**Re: GE-Pittsfield/Housatonic River Site
Lyman Street Area (GECD430) – Properties East of Lyman Street
EPA Requested Information and Analytical Data for Proposed Topsoil Source**

GENERAL ELECTRIC COMPANY • PITTSFIELD, MASSACHUSETTS
 LYMAN STREET AREA REMEDIAL ACTION

REVISED ENGINEERED BARRIER FINAL GRADE PLAN

REVISED ENGINEERED BARRIER DETAIL

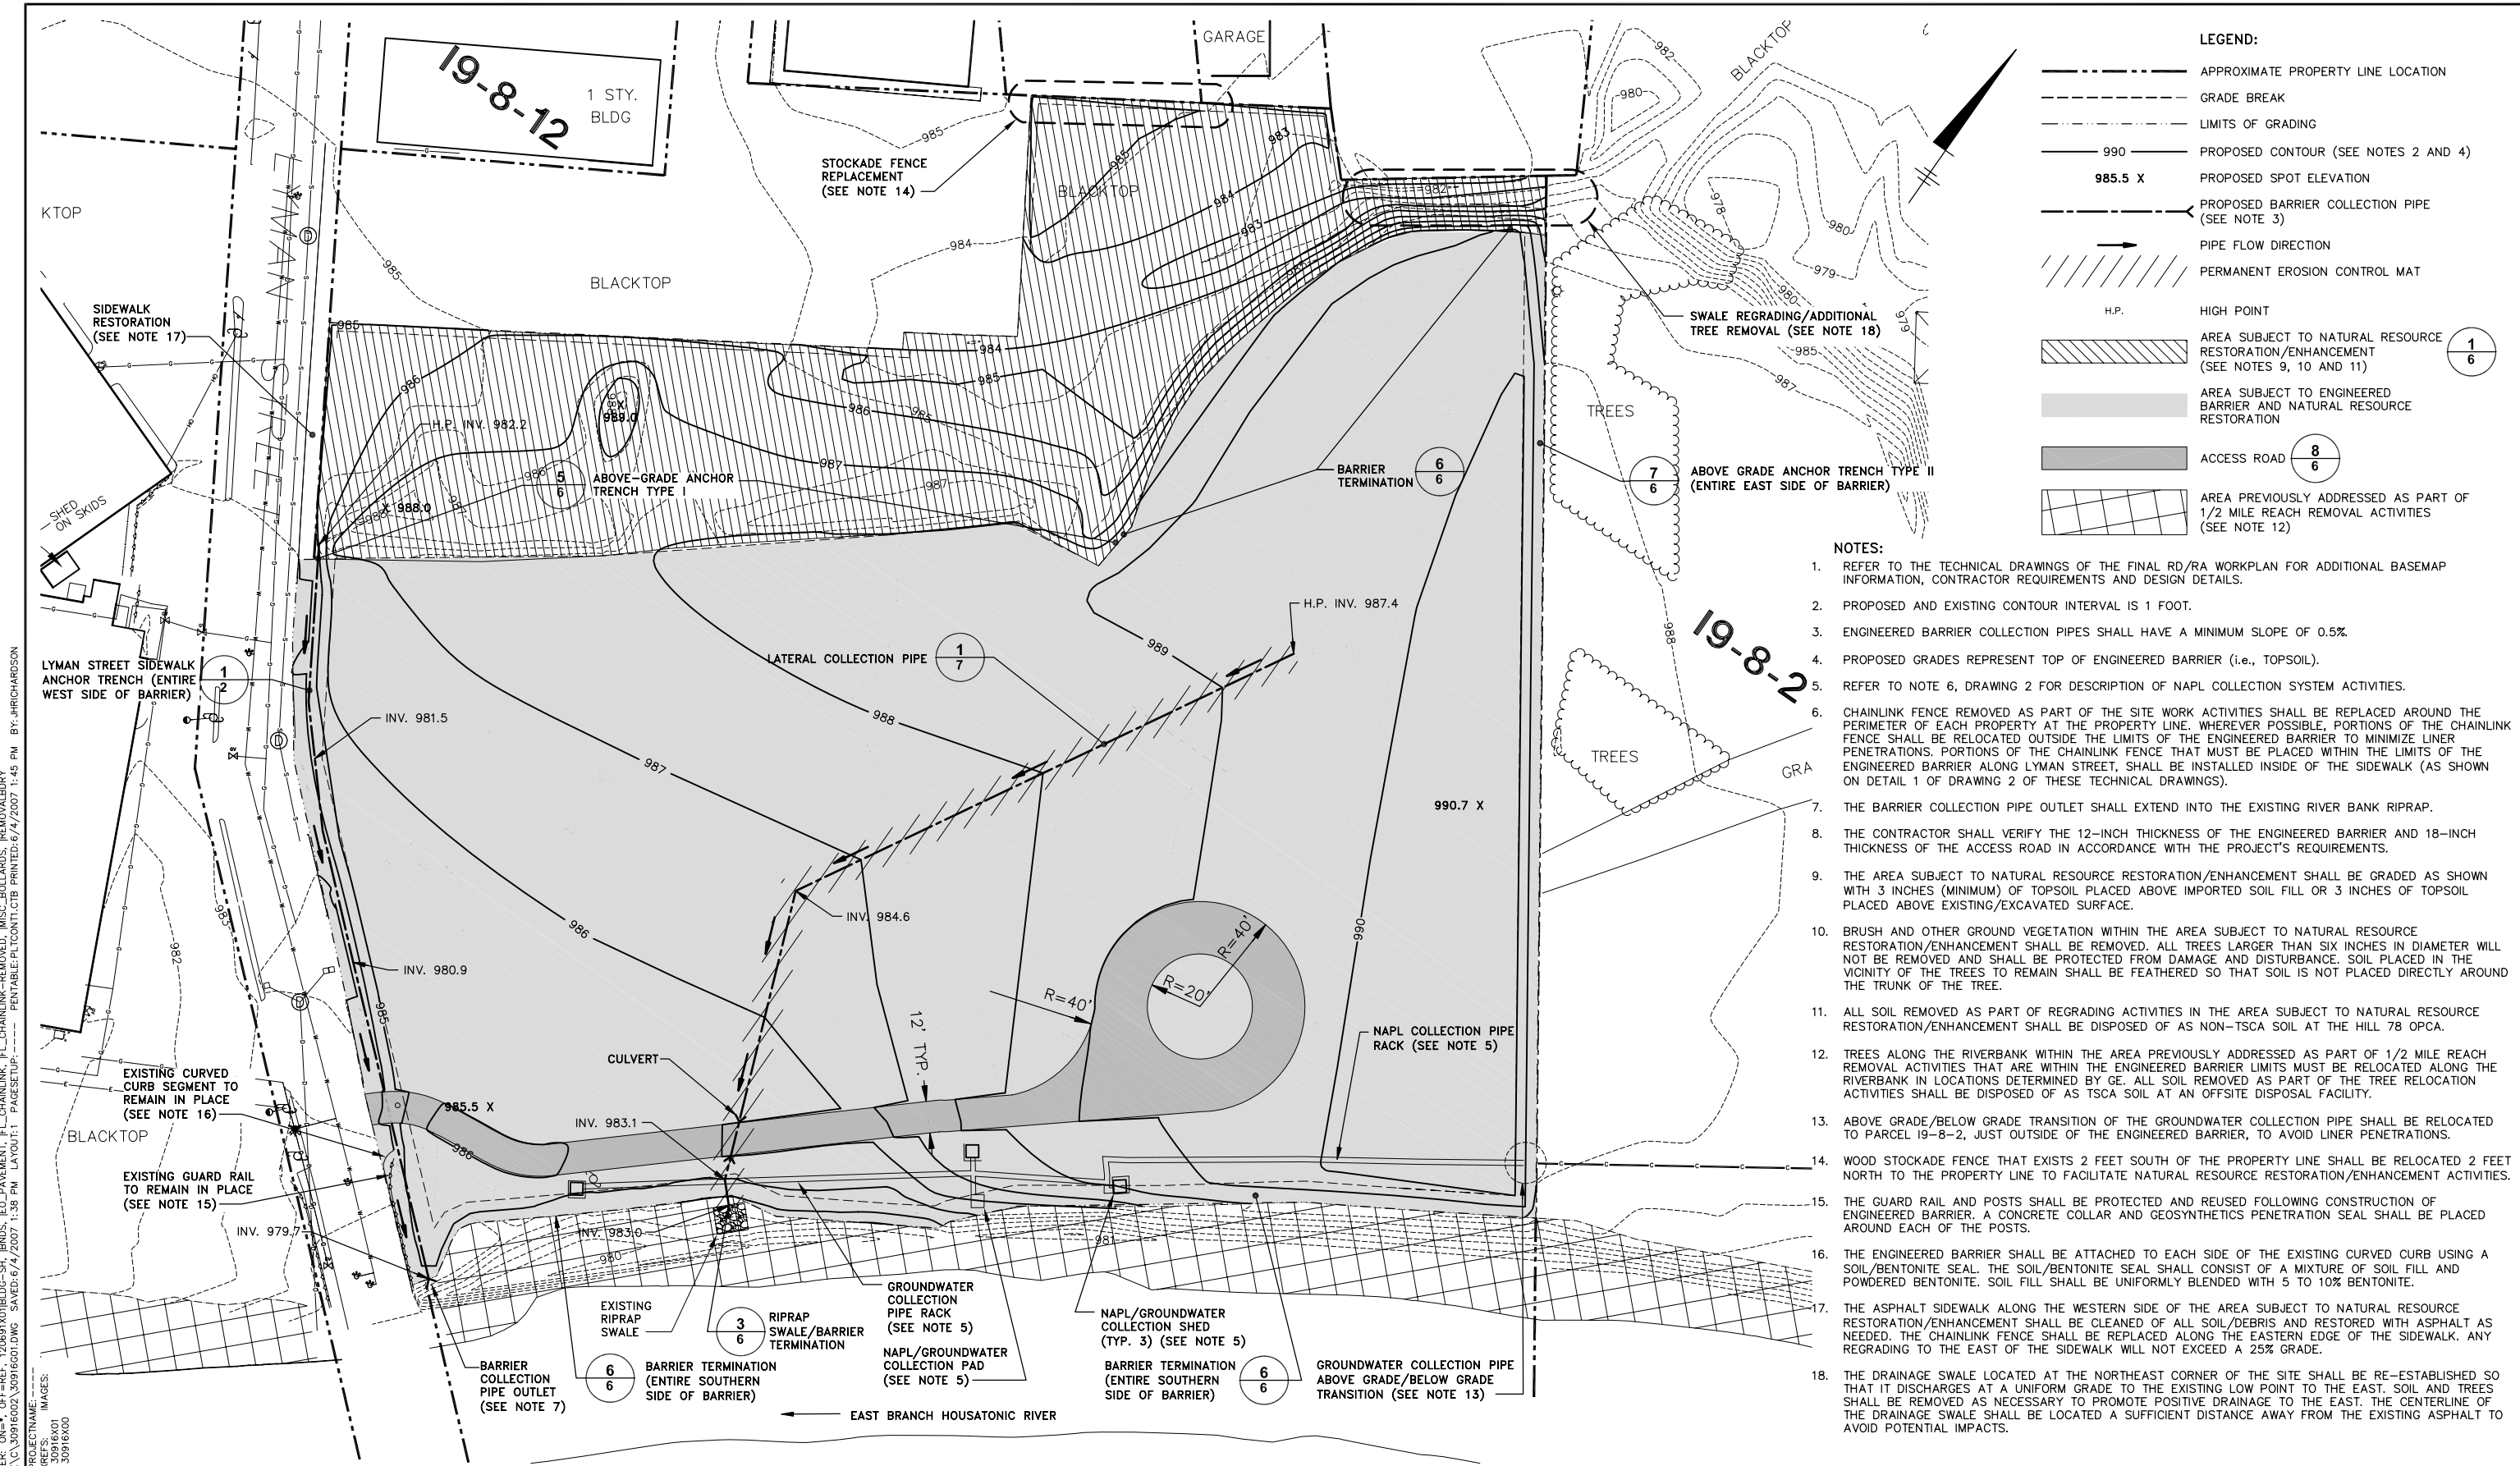
The attached Revised Engineered Barrier Final Grade Plan and Revised Engineered Barrier Detail drawing (Attachment 1) address the following construction activities:

- extension of the engineered barrier to the edge of curbing along Lyman Street;
- installation of additional curbing along Lyman Street;
- improvement of the sidewalk along Lyman Street;
- replacement of the chainlink fence along the Lyman Street sidewalk within the engineered barrier;
- placement of the engineered barrier around a segment of curved curbing and a guard rail; and
- removal of trees and soil to promote drainage along the swale in the area subject to Natural Resource Restoration/Enhancement.
